## **Bath Clean Air Plan**

Bath and North East Somerset Council

### **OBC Consultation Response Report**

674726.BR.042.FBC-25b | 2

**Figure 3.1 Reduced Clean Air Zone (CAZ) extent considered (removing the A36 and the A4/Cleveland Place junction)**

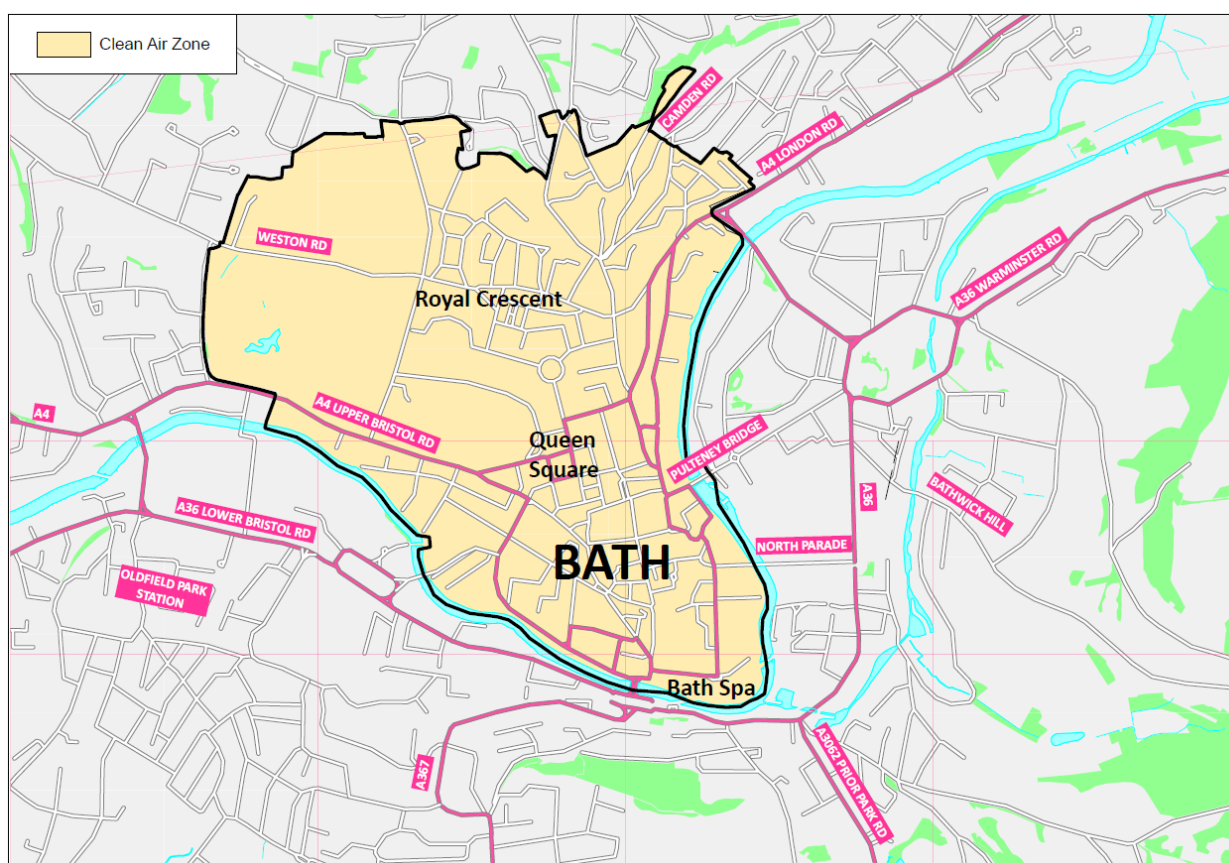
A common suggestion was that the A36 and A4 should be excluded from the zone as these are through routes used by traffic moving through and around Bath. In response to this feedback, additional traffic and air quality modelling work was undertaken to examine the extent to which compliance with the required air quality targets could be delivered with a smaller zone as shown in Figure 3.1. This removed all sections of the A36 and the A4 London Road/Cleveland Place junction from the zone.

Detailed reporting of this work can be found in Appendix A. In summary, this highlighted that this smaller zone would result in five exceedances of air quality and therefore not be sufficient to deliver the required reductions in emissions. Specifically, these were identified at:

Figure 3.2 – Revised Class D CAZ boundary, following consultation

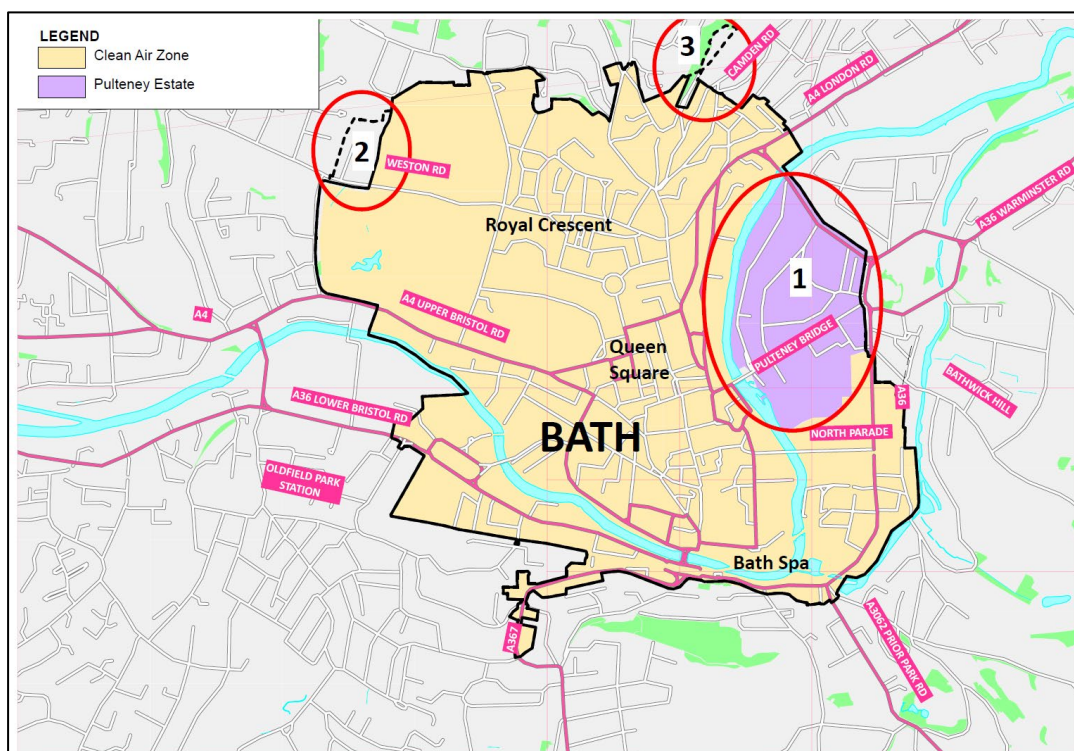
The consultation feedback also included requests for specific smaller areas to be excluded from the CAZ. These comments are set out in detail in Chapter 7 of FBC 25a – Report on Formal Consultation. These typically related to areas on the edge of the proposed boundary, or where respondents had identified that minor amendment could mean that their street may not be unnecessarily disadvantaged by the CAZ. In most cases the implication was that respondents were asking for the boundary to be drawn closer to the main routes, and not to include the side roads. In some cases, there were parallel requests from others who would prefer to see the boundary enlarged in the same area.

The boundary of the proposed Class D CAZ has been amended as shown in Figure 3.2, based on consideration of the consultation feedback (as detailed above) and technical review. This differs from the consultation version by:

- Including the Pulteney Estate area (Area 1 in Figure 3.2);
- Excluding Rivers Road (Area 3 in Figure 3.2); and
- Excluding Cranhill Road (Area 2 in Figure 3.2).

Figure 3.3 – Other possible boundary amendments under technical review

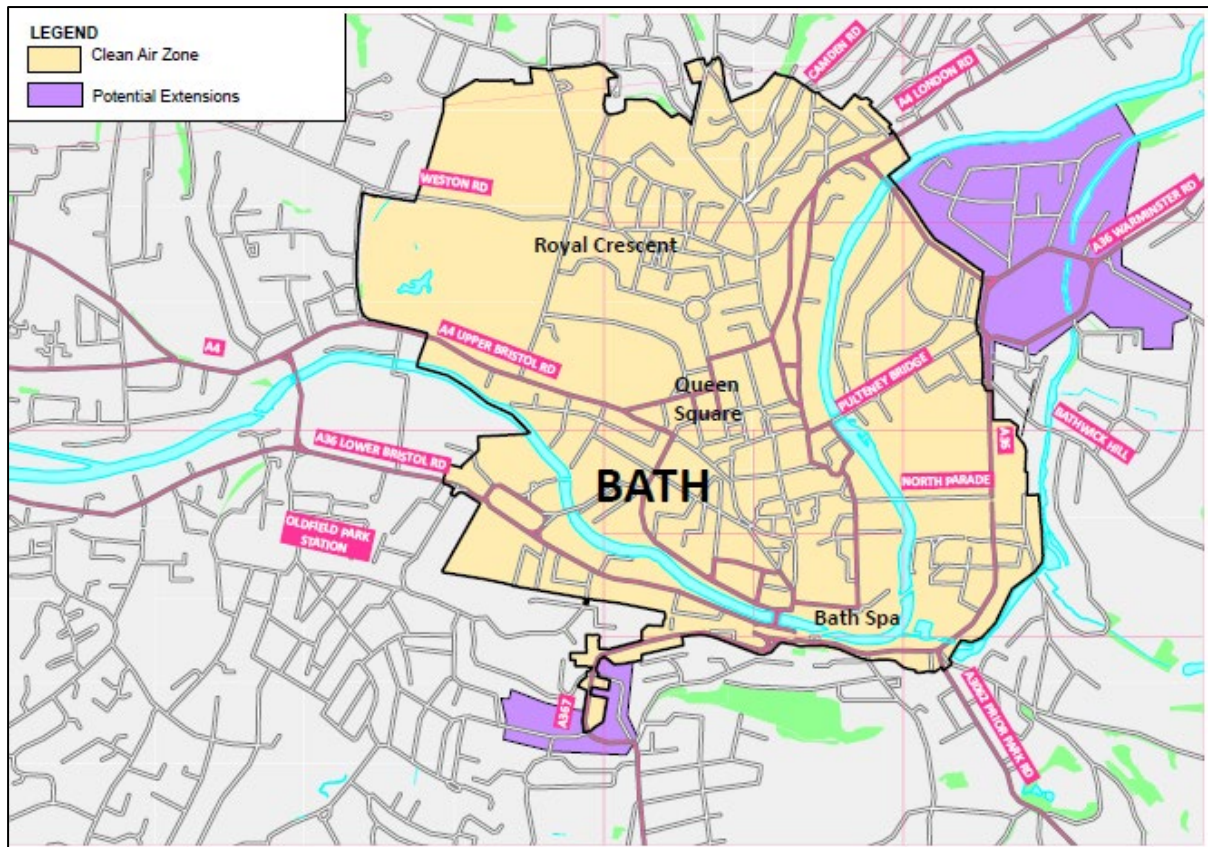
Additionally, other possible amendments highlighted in Figure 3.3, remain under technical review.

**Figure 2.1 Reduced Clean Air Zone (CAZ) Extent - Removing the A36 and the A4/Cleveland Place Junction**

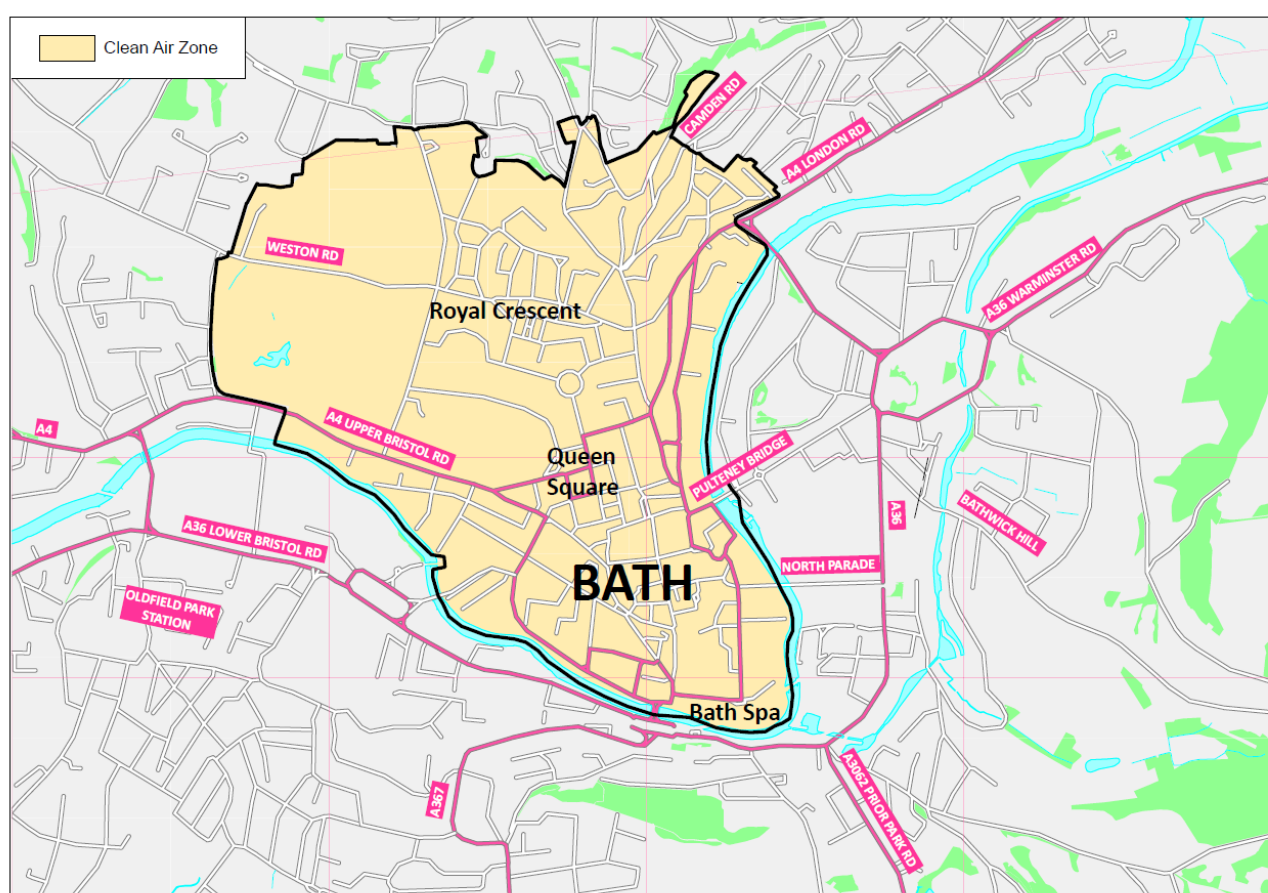
**Figure 2.1** below shows the reduction to the CAZ specifically tested in this scenario. The whole of the A36 corridor presently included between the Brougham Hayes junction and Bathwick Roundabout is removed. This also removes the included northern part of the A367 Wells Road between Oldfield Road and Churchill Gyratory where, as noted earlier, there is an existing air quality exceedance. To the north of the A36 Pines Way, the Sainsbury's store and other developments served off Ivo Peters Road are also removed from the zone, which would otherwise require a new CAZ cordon point to be established here.

It is accepted that 'tucking in' the zone to the south, so maintaining the A36 route through Bath 'outside' of the CAZ, would assist in addressing 'rat-running' or 'avoidance' concerns, particularly to residents in Upper Oldfield Park/Oldfield Park. The original small CAZ considered at 'Strategic Outline Business Case (SOBC) Stage included just the A36/A367 Churchill Gyratory, but this still severed the east-west A36 route and the A367 radial route into/out of Bath to the south. As a result, the extent of the A36 included in the CAZ was necessarily increased to cover the potential 'rat-runs' via the White Hart junction (Widcombe) and the B Class route between the A367 and the A36/Brougham Hayes junction (Oldfield Park). As a result, it presently now encompasses Sainsbury's, the filling station in this location and the Esso filling station on the A36 Lower Bristol Road just west of the Churchill Gyratory. To the north of Widcombe, the A36 Pulteney Road was included to prevent non-compliant vehicles from using unsuitable roads to turn around and avoid zone entry, with 'U' turns possible at Bathwick Roundabout for all vehicles, including HGV's.
